Hematite Decommissioning Plan Chapter 6 - Environmental Information

Hematite Decommissioning Plan Chapter 7 – ALARA Analysis

Figure 1
Process Building Underlying Soil Sampling Locations - 2010

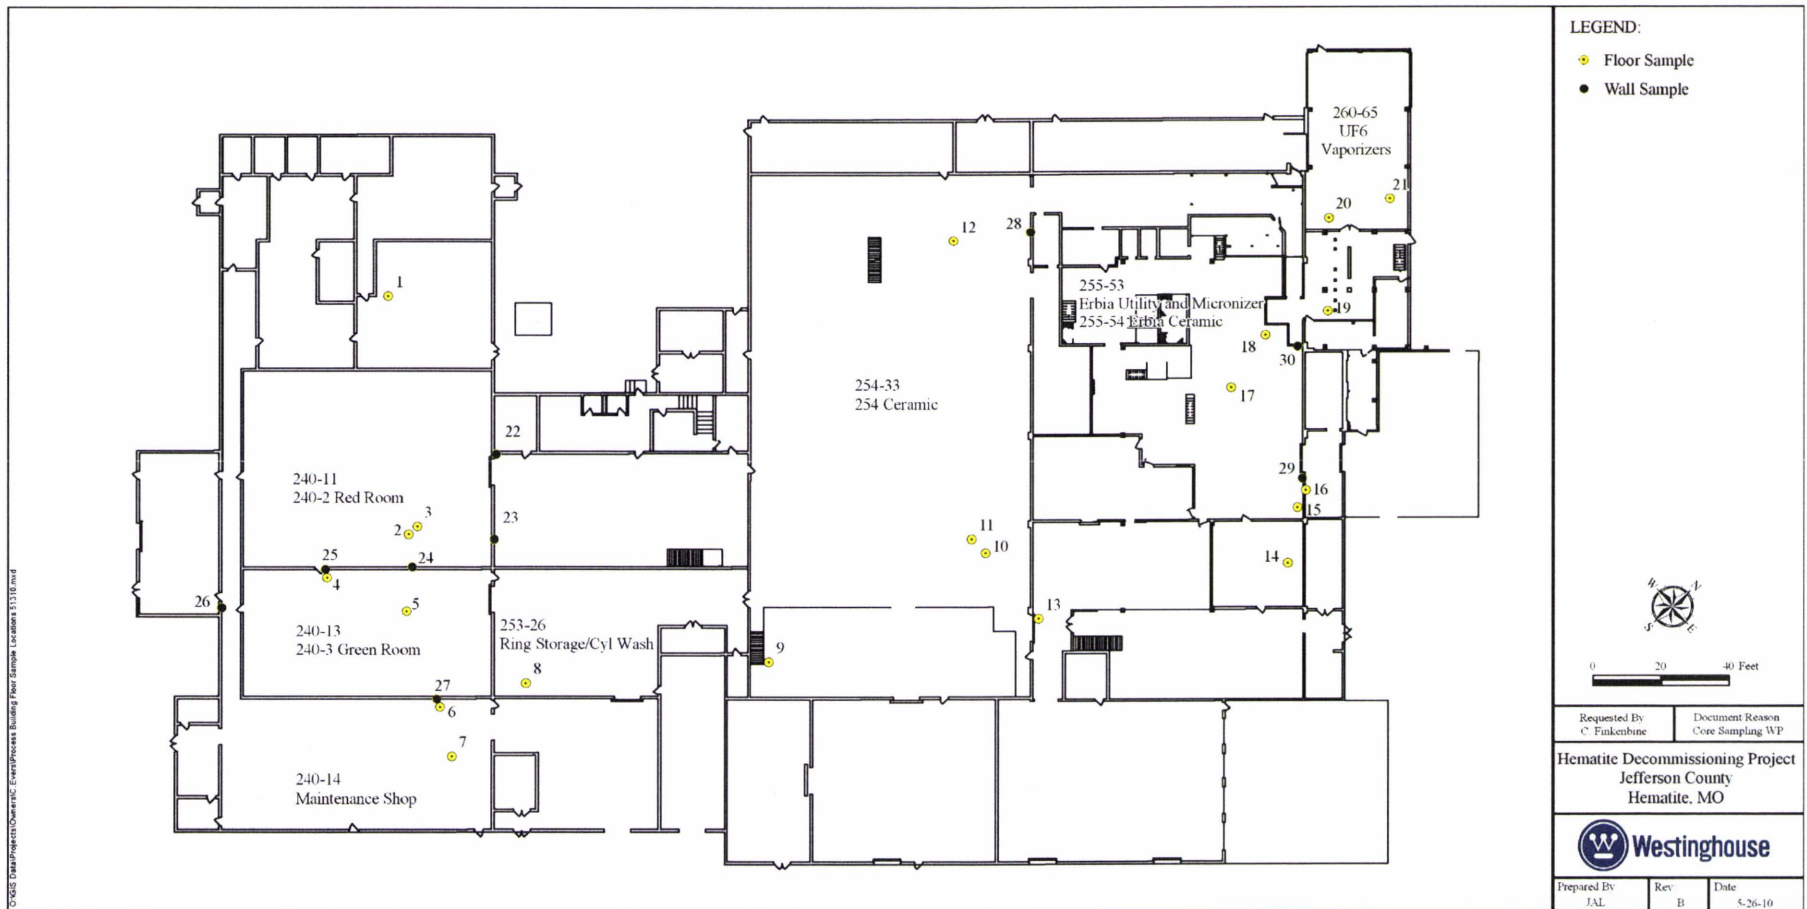
6. (HDP-4-Q6) Figures 4-6 and 4-7, Impacted Area – Surface Soil Contamination, show areas under buildings that have significant radioactivity. How were these areas and the radioactivity contours determined?

Path Forward: Provide details on how the radioactivity under the buildings was determined and how the radioactivity contours determined.

Details on how the radioactivity under the buildings was determined and how the radioactivity contours were determined, are provided in the response below.

During the characterization surveys conducted by SAIC, Energy Solutions, and Westinghouse as discussed below, sampling was performed to access the soil underlying the buildings to determine the amount of radioactivity. A concrete coring bit was used to remove a portion of the concrete floor surface at each of the soil sampling locations. After removing the concrete surface, soil samples were obtained and provided to a laboratory for analysis.

In November 2003, SAIC conducted sampling inside the building structures and obtained soil samples from the fill beneath the concrete floor; the soil immediately beneath the fill; and from sub-surface soil at each location referenced in HRCR Section 4.8.1.1. Additionally, SAIC obtained sub-surface soil samples at locations adjacent to the exterior of the buildings in the spring and summer of 2004 as also referenced in HRCR Section 4.8.1.1.

During November 2007, Energy Solutions obtained additional characterization samples of subsurface soil, including the soil beneath the buildings to remain at the time of license termination, as described in HRCR Sections 4.8.1.2 and 4.20.

The various contours included in DP Figures 4-6 to 4-12 are based on the ranges of radionuclide concentrations listed in the legend on the figures. The ESRI ArcGIS, Version 9.2¹ software was used to place the boundaries for each contour based on those concentration ranges. The boundaries were then manually re-positioned between samples belonging to the various ranges of concentration based on professional judgment. The decisions for final positioning of the boundaries included considerations of the magnitude of the specific sample being examined, and the concentration of the surrounding samples in close proximity.

During 2010 (subsequent to submitting the DP) Westinghouse performed coring of the concrete floors to more extensively characterize the depth of penetration and radionuclide contribution to contamination in concrete. After removing the concrete cores, Westinghouse was afforded the opportunity to obtain additional samples of the underlying soil/gravel fill. These sampling locations are illustrated on Figure 1, and the associated laboratory analytical data are provided in Table 1, below. Please note that these sample results are not included in the contour maps previously discussed.

Figure 4-8
Impacted Area – Surface Soil Contamination – Th-232

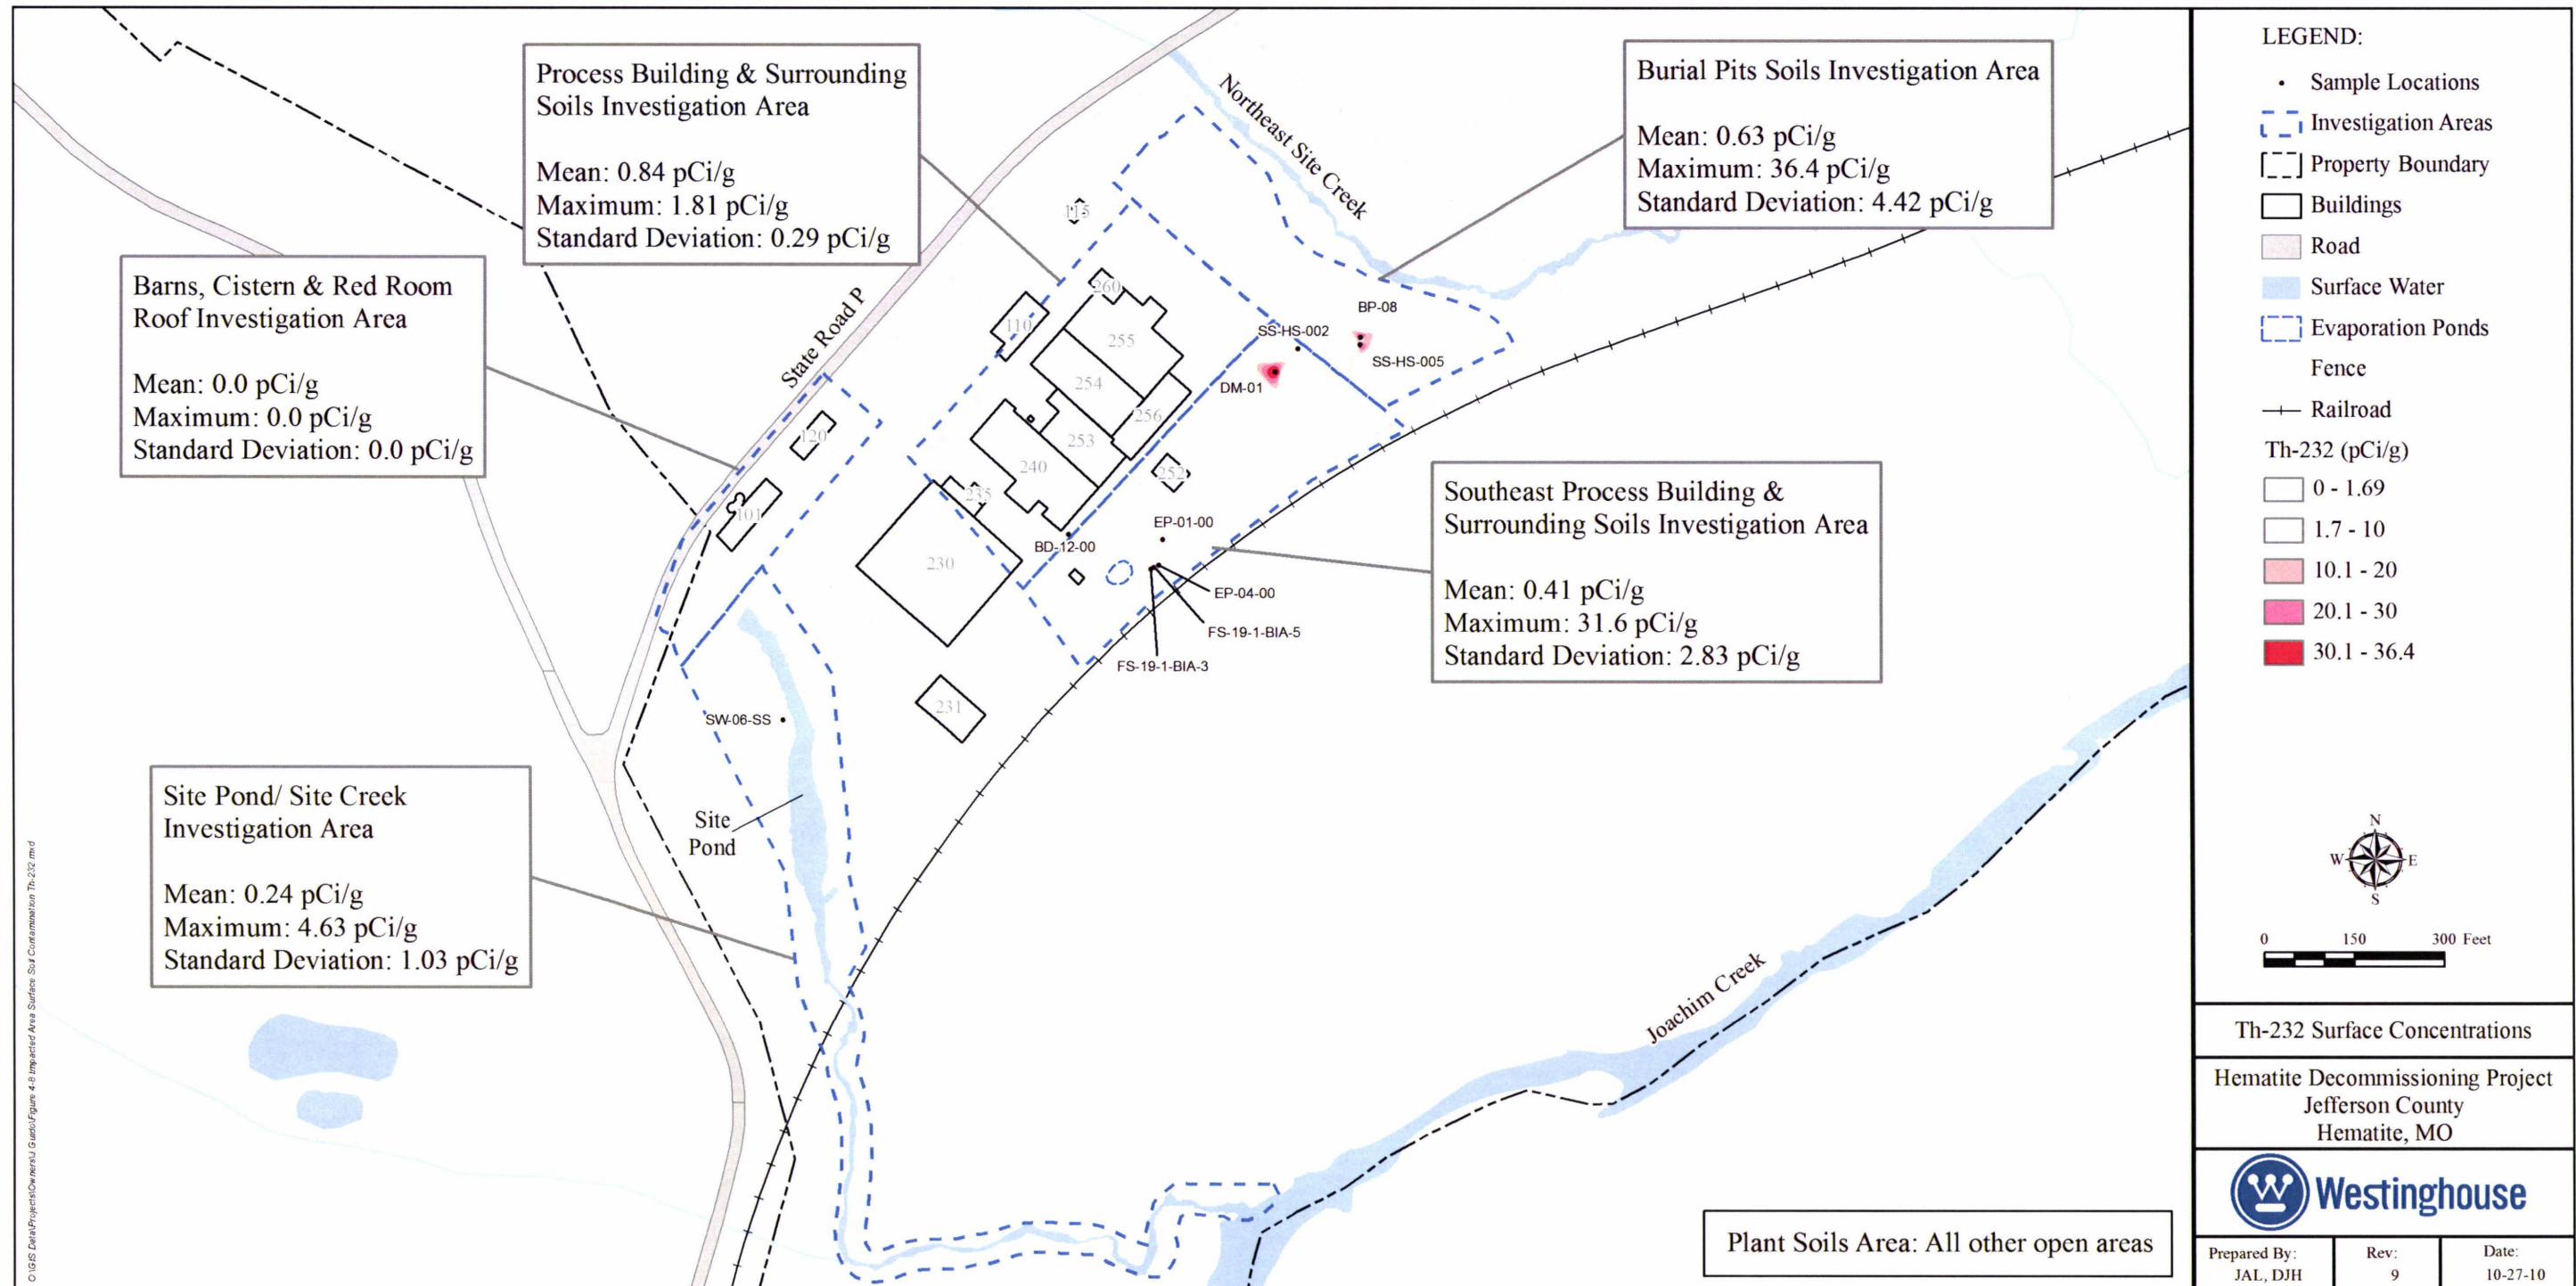
7. (HDP-4-Q7) Comment: Figure 4-11 Impacted Area – Sub-Surface Soil Contamination – Th-232 shows that the Burial Pits Soils have a thorium-232 mean specific activity of 34.74 pCi/g and a maximum of 6870 pCi/g. The legend shows that this area is well within the red colored areas used to designate these activity levels but there is no red colored areas identified.

Path Forward: Update Figure 4-11 to reflect the burial pit soil data consistent with the legend for the Figure.

In addition to better identify the shaded areas, sample locations outside of the shaded areas have been removed from DP Figure 4-8, Impacted Area – Surface Soil Contamination – Th-232, and Figure 4-11, Impacted Area – Sub-Surface Soil Contamination – Th-232 so that the shaded contours can be better discerned. Additionally, to assist in the review of these figures, the sample IDs for the remaining sample points that are relevant to the evaluation of Th-232 have been added.

The updated figures are shown below; the DP will be revised accordingly.

Figure 4-13
Surface Water Features

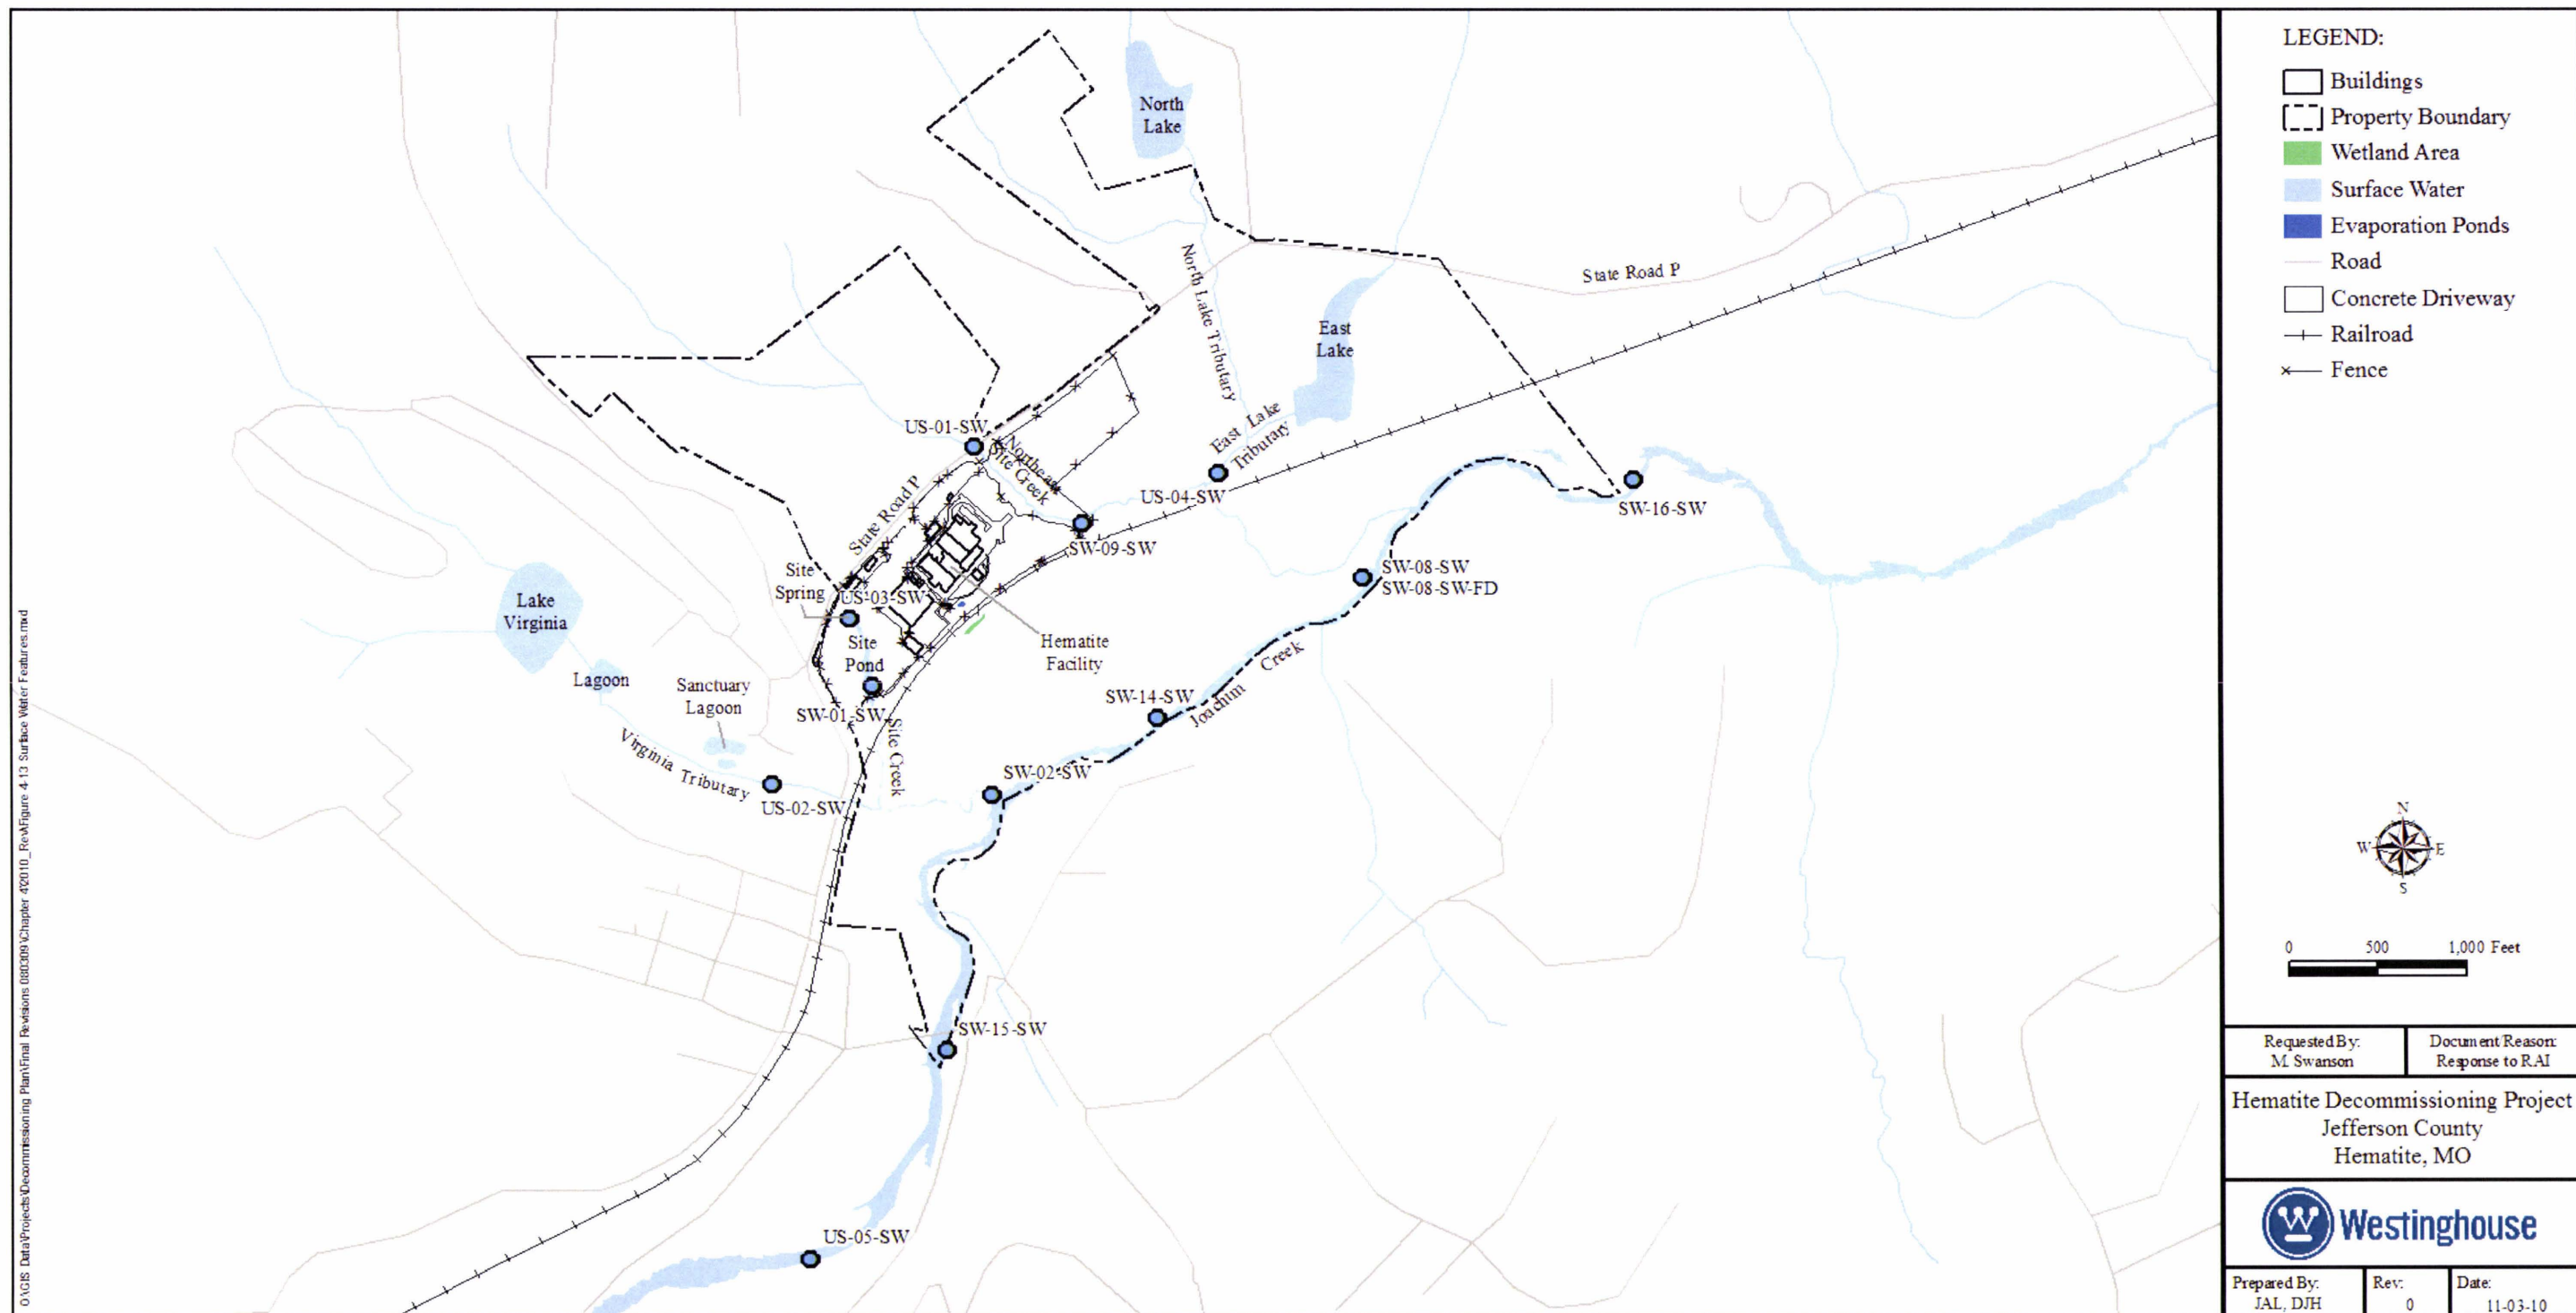
10. (HDP-4-Q10) Comment: Statistical results of surface water monitoring were given in Table 4-27. However, the locations for the monitoring stations and analytical data were not included.

Path Forward: Provide a monitoring data table for each monitoring station, with an updated Figure 4-13 showing the surface water monitoring stations.

DP Figure 4-13 is updated to include the surface water sampling locations. A copy of the updated DP Figure 4-13 is provided below.
